**Re: Ameren Missouri  
Sioux Power Station  
Response to Dewberry & Davis Draft Coal Combustion Waste Impoundments  
Round 7 – Dam Assessment Report**

RE: Ash Pond Dam Stability Analysis  
Sioux Power Station

## Inverted Filter General Location and Extents

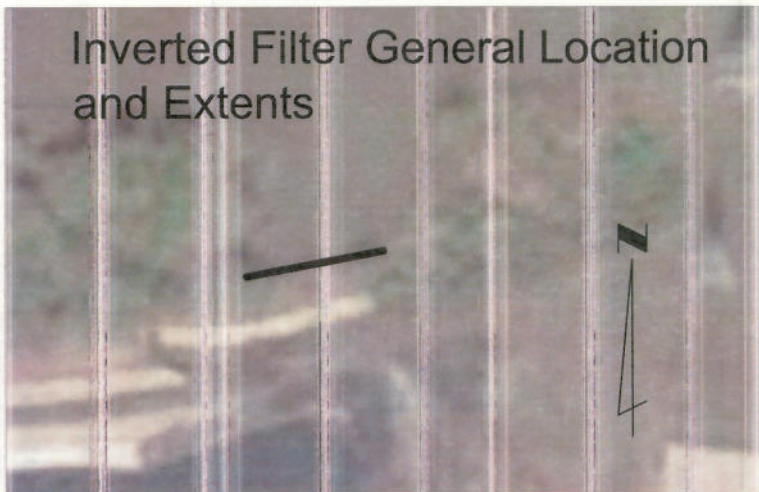
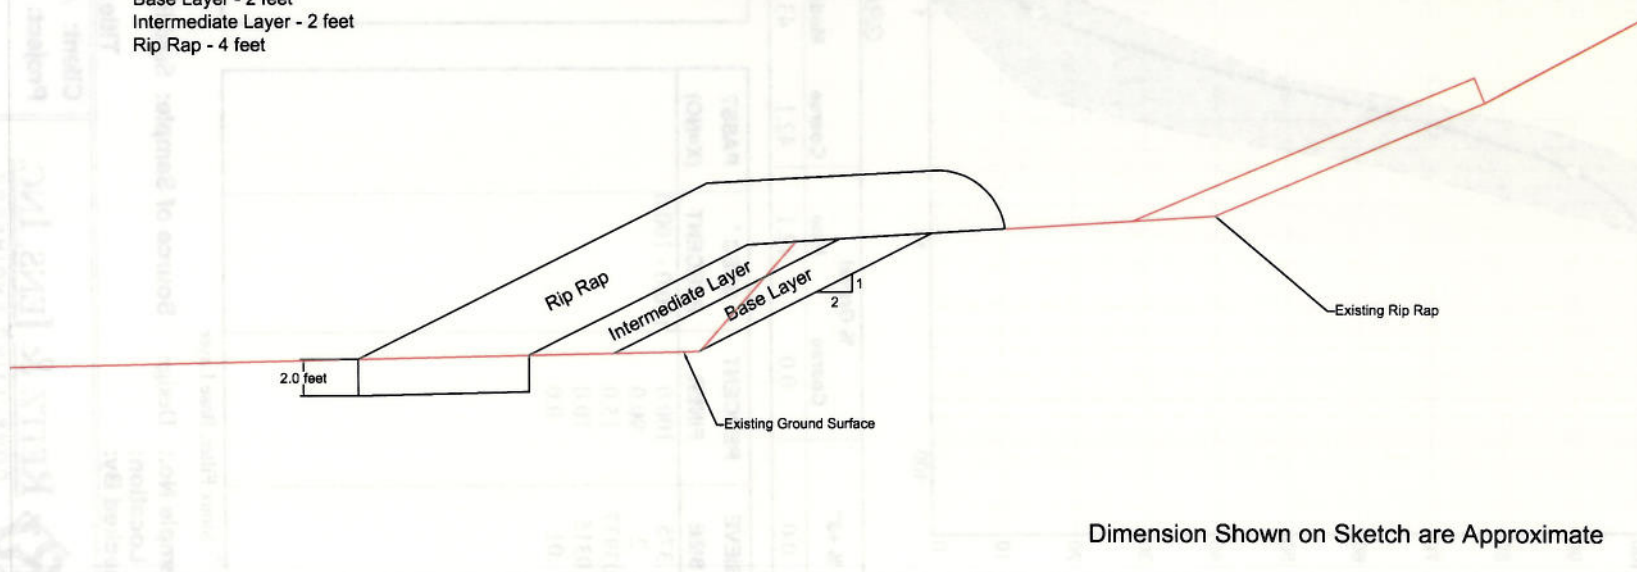
**1.1.5. Conclusions Regarding the Field Observations: A small seep in the northeast corner of the Bottom Ash Pond dam was observed 75' from the toe of the embankment with clear water exiting the area. AmerenUE is monitoring the situation on a weekly basis.**

Observations of the seep show that the sediment yield is intermittent. The history of the seepage area is unknown. We recommend constructing an inverted filter over the bank of the seepage area to help stop the migration of fines from within the embankment. The details of the filter are presented in Appendix C. The filter should generally consist of a two foot thick base layer of coarse sand above the existing ground surface. The coarse sand should be overlain with a two foot intermediate layer consisting of gravel. Four feet of rip rap is recommended at the surface of the filter to protect against wave and current erosion. The recommended gradations for the coarse sand, and gravel and rip rap are presented in Appendix C. A sketch of the approximate location, limits of the filter and a typical cross-section of the filter are also presented in this appendix.

Response: Ameren Missouri will continue to monitor the seepage for clarity and volume fluctuations during the weekly inspections. Ameren has initiated a project to install an inverted filter along the seepage area and plans to implement this project in 2011.
